**State of Connecticut**  
**Department of Transportation**

**SUPPLEMENTAL SPECIFICATIONS**  
**TO**  
***STANDARD SPECIFICATIONS FOR***  
***ROADS, BRIDGES, FACILITIES AND***  
***INCIDENTAL CONSTRUCTION***

**JANUARY 2021**

**Figure 4.07-1: DETAILS AND SECTIONS OF RUMBLE STRIPS**

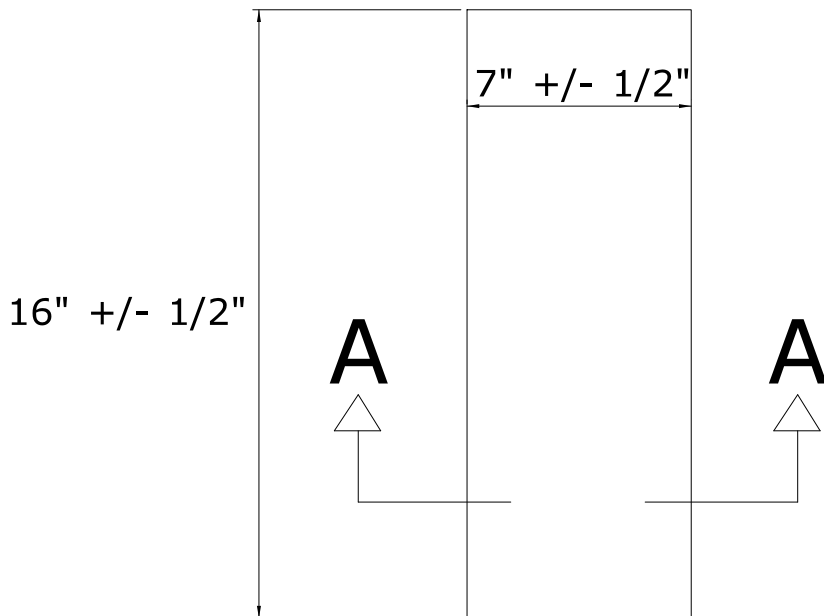
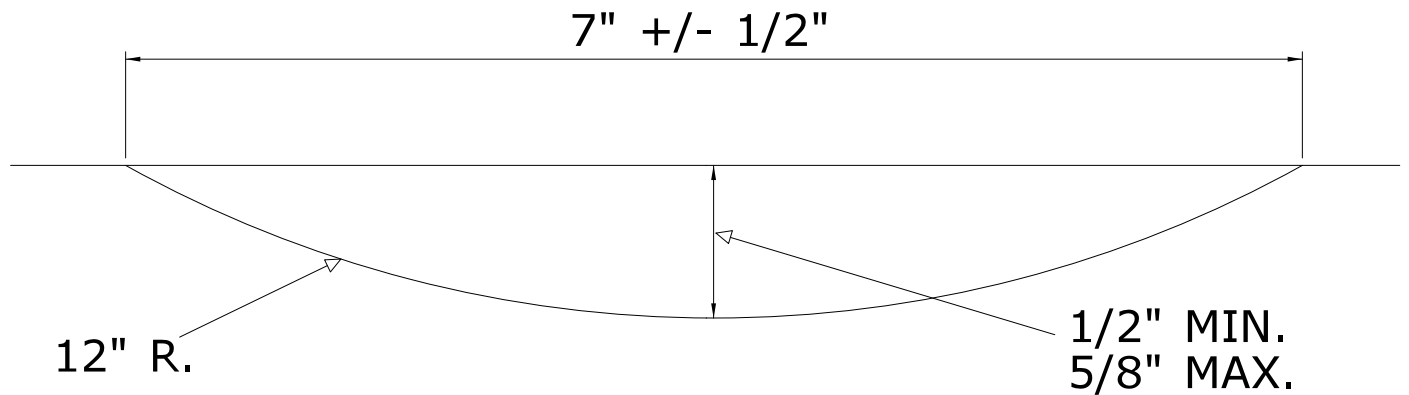
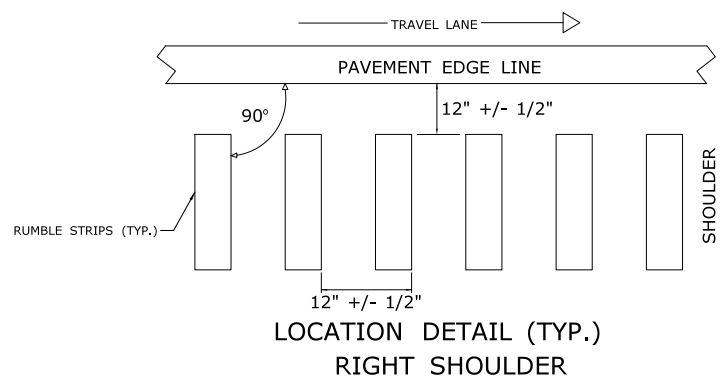
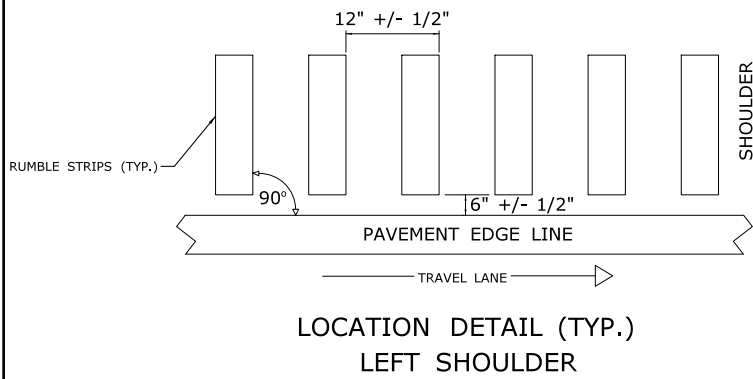
After Section 4.06, add the following New Section 4.07:

to the patterns shown in the plans or in Figure 4.07-1. Alignment of the edge of the cut shall be checked and verified by the Engineer.

RUMBLE STRIP ALIGNMENT SHALL GENERALLY BE STRAIGHT AND OFFSET APPROXIMATELY 6" IN THE LEFT SHOULDER AND 12" IN THE RIGHT SHOULDER FROM THE OUTER EDGE OF THE EDGE LINE, AND SHALL BE AT LEAST 12" FROM THE LONGITUDINAL JOINT IN COMPOSITE PAVEMENTS. THIS OFFSET MAY BE ADJUSTED TO ACCOMMODATE VARIATIONS IN THE EDGE LINE AND THE SHOULDER WIDTH.
